10 Oil loss from the filler cap

10 20 19 2059446/2 July 14, 2020. Supersedes Technical Service Bulletin Group 10 number 20-18 dated May 12, 2020 for reasons listed below.

Figure 1. Breather line that needs to be replaced.

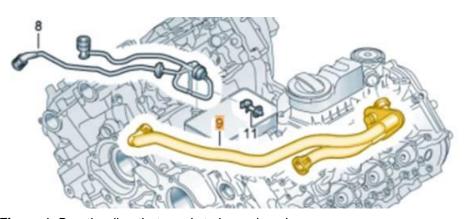
A faulty membrane in the breather line 06M103210 ** can result in excess pressure in the crankcase and therefore some oil loss through the filler cap.

A breather line with an improved membrane has been implemented in production.

Replace the breather line 06M103210 ** (different variants available, only order by VIN).
